CMB Meeting Minutes #176

SUBJECT: Configuration Management Board Meeting # 176 – Rev. No. 0

Project No. M544.1, Contract No. CS-149
Program/Construction Management
Configuration Management Board (CMB) Meeting No. 176
July 02, 2014
3:00pm – 5:00pm
Central Subway Project Office
821 Howard St. 2nd Floor
Main Conference Room

CHANGE ORDER REQUEST NUMBER 070**SFMTA Contract No. 1252**
CENTRAL-SUBWAY-TUNNELING**Contractor:** Barnard Impregilo Healy JV
420 Fourth Street
San Francisco, CA 94107**SUMMARY RECORD OF NEGOTIATIONS****SCOPE OF WORK:**

CONTRACT NO. 1252
SFMTA CONTROL NO. CL-18168
DRAWING NO. ES-163
REVISION 1

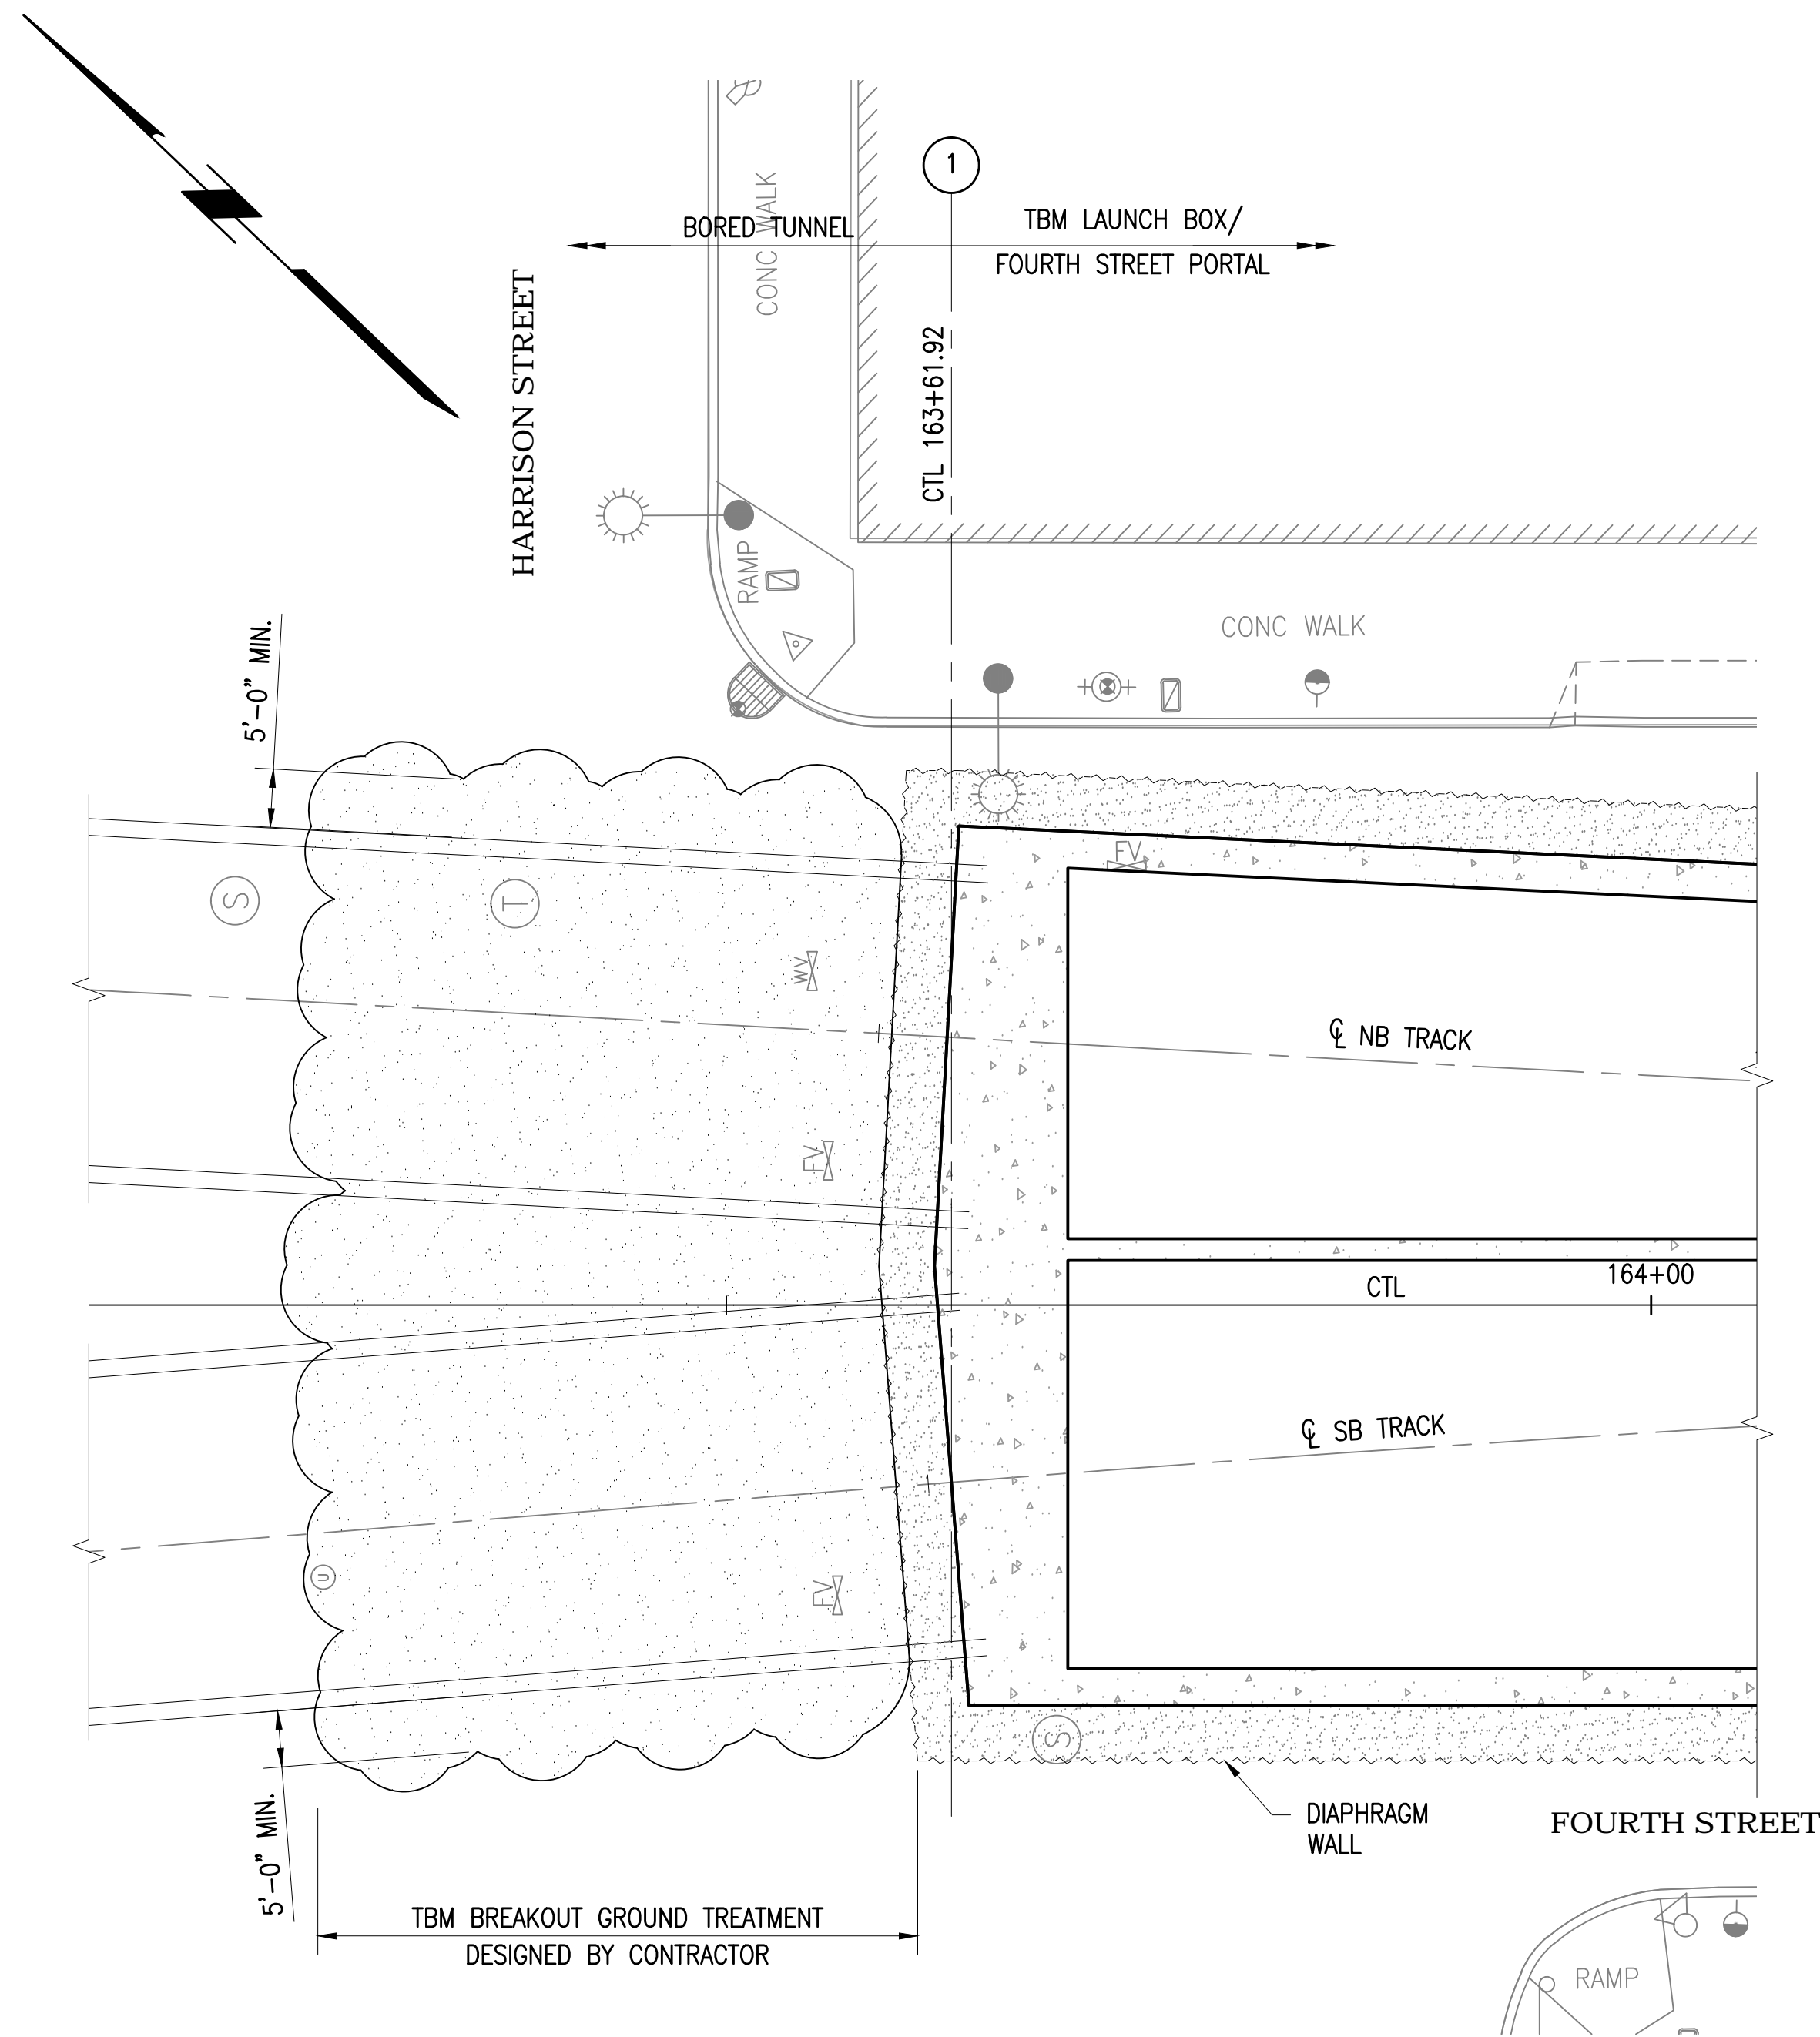
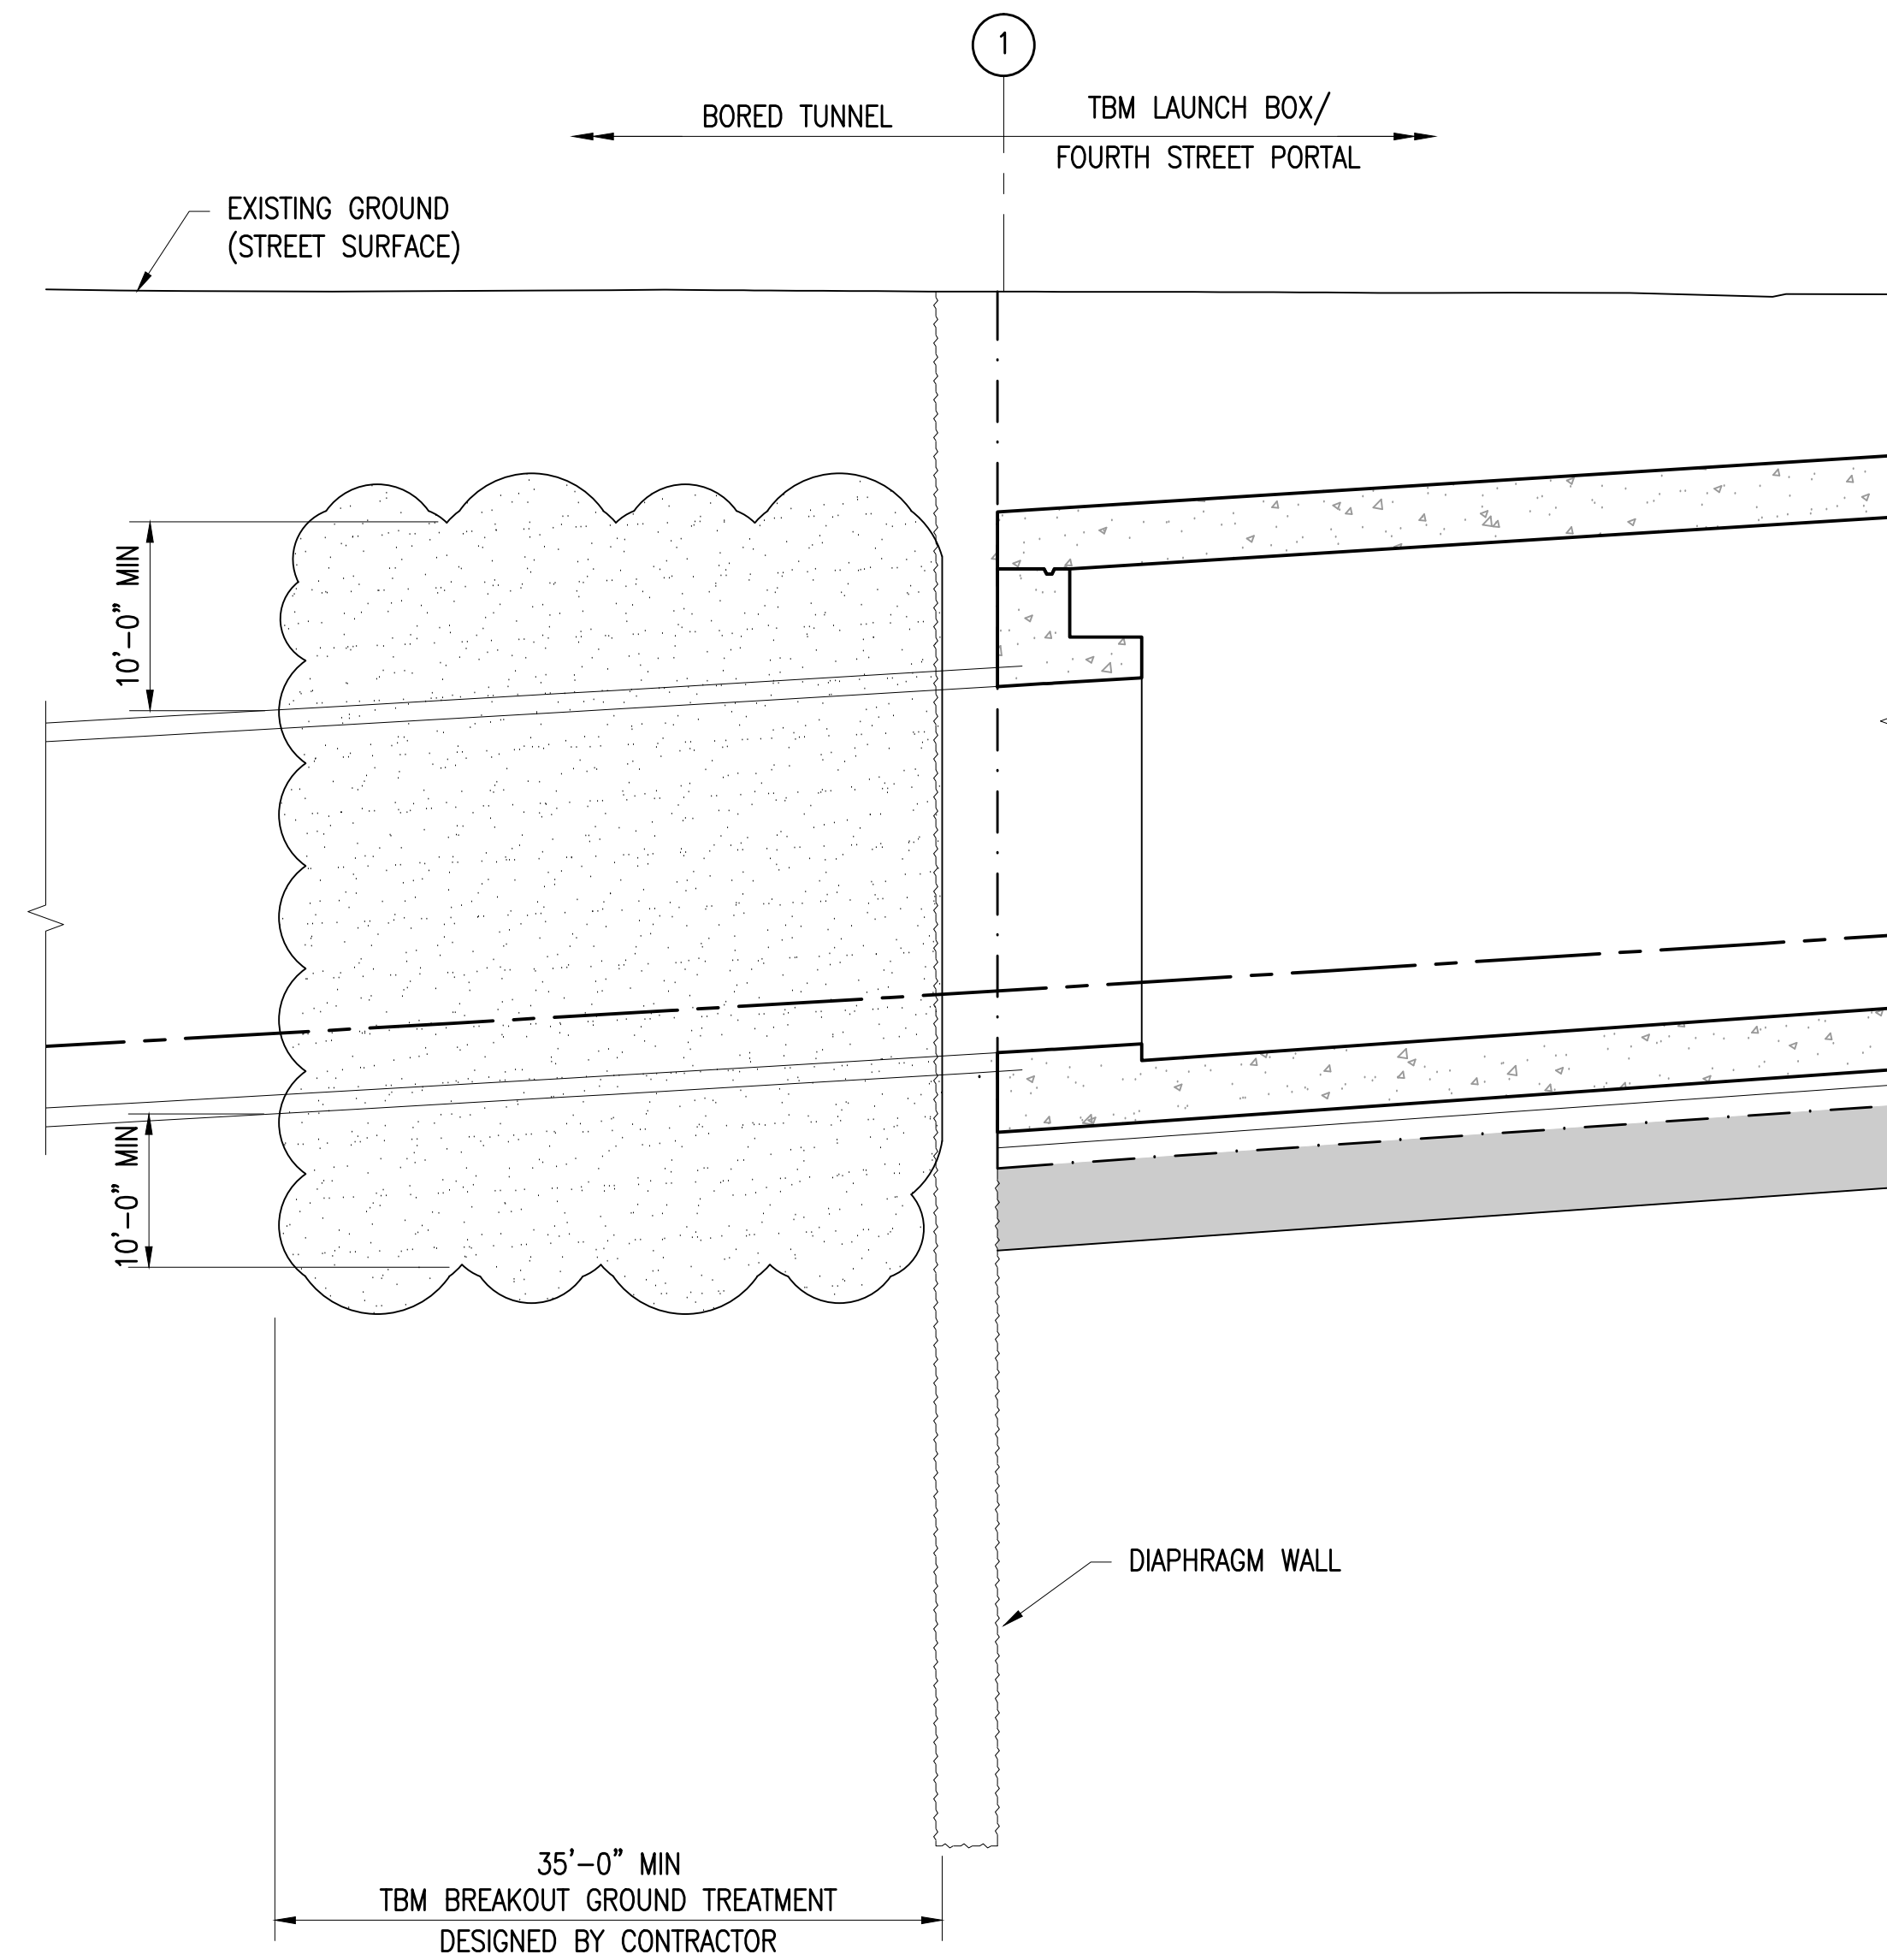
Contract Drawing ES-163 Rev.1 provides minimum dimensions for the extent of the ground treatment for the TBM launch box. A note on the plan and section view of the drawing also indicates that the TBM Breakout Ground Treatment is "Designed by Contractor." Note 8 on the same drawing states, "Grout to be designed by the Contractor. The Contractor shall develop the proposed grouting plans based on the conditions at the TBM Launch Box and the requirements shown on this sheet. The Contractor shall submit the proposed grouting plans to Engineer for review and approval."

The main purpose for having a Soilcrete breakout zone is to provide relatively impermeable ground for the Tunnel Boring Machines (TBMs) to start mining within. The minimum dimensions were not sufficient to produce a large enough Soilcrete breakout zone for a safe TBM breakout because the overall length of the TBM shield and cutterhead exceeds the minimum length shown in the Contract Drawings. The zone had to be sized to allow installation and backfill grouting of at least one ring of the tunnel liner to provide a watertight seal to develop between the treated impermeable ground and the tunnel liner. Once a satisfactory seal has been developed, the TBM may safely exit the improved ground with a reduced risk of water and soil inflow into the tunnel/TBM Launch Box interface. The lack of a sufficient seal in un-improved ground would result in water and soil inflow which would likely cause significant and potentially catastrophic ground settlement at the breakout (i.e. the intersection of 4th and Harrison). The Contractor designed the minimum jet grout layout to provide for the development of a sufficient seal. The design allows for the encapsulation of the TBM and one ring with only 1.8' of cover between the TBM cutterhead and edge of jet grout. The Contractor has provided additional protection by installing a breakout seal prior to mining.

On April 23rd, 2013, the Contractor sent letter no. 120 which stated that BIHJV disagreed with SFMTA's determination that 3,688 CY represents the total extent of ground treatment indicated on Contract Drawing ES-163 Rev.1 and that they would submit a written COR for the remaining 241 CY which was in disagreement.

Contract Drawing ES-163 depicts the minimum extents of the TBM Breakout Ground Treatment. It should be noted that the bid quantity is actually lower than the theoretical volume of the soilcrete zone shown in ES-163, using the minimum dimensions given therein. The minimum dimensions were not sufficient to produce a large enough soilcrete breakout zone for a safe TBM breakout. The main purpose for having a soilcrete breakout zone is to provide relatively impermeable ground for the TBMs to start mining within. The zone must be sized to allow installation and backfill grouting of enough of the tunnel liner to provide a watertight seal to develop between the treated impermeable ground and the tunnel liner. Once a satisfactory seal has been developed, the TBM may safely exit the improved ground with a reduced risk of water and soil inflow into the tunnel/TBM Launch Box interface. The lack of a sufficient seal in un-improved ground would result in water and soil inflow which would likely cause significant and potentially catastrophic ground settlement at the breakout (i.e. the intersection of 4th and Harrison). Therefore, BIHJV has designed the minimum jet grout layout to provide for the development of a sufficient seal.

1. Contract Drawing ES-163:
 - a. Every dimension shown for the ground treatment zone is given as a minimum dimension
 - b. Numerous dimensions include a note that specifically states "TBM Breakout Ground Treatment designed by Contractor"

- c. Note 8 states, "Grout to be designed by the Contractor. The Contractor shall develop the proposed grouting plans based on the conditions at the TBM Launch Box and the requirements shown on this sheet. The Contractor shall submit the proposed grouting plans to Engineer for review and approval.

SFMTA determined that due to ambiguity in delineating compensable in-situ jet grout, compensating the Contractor for in place jet grout volumes would be a fair and reasonable resolution. A determination would most likely be found in favor of BIHJV if Claim No. 04 were brought before the Dispute Resolution Board or litigation, and that the requested amount (\$168,700) was fair and reasonable based on the confirmed in-situ quantities and verified ES-3 Bid Item unit price (\$700/cubic yard). The unit price was previously verified by separate analysis included with Contract Modification No. 22.
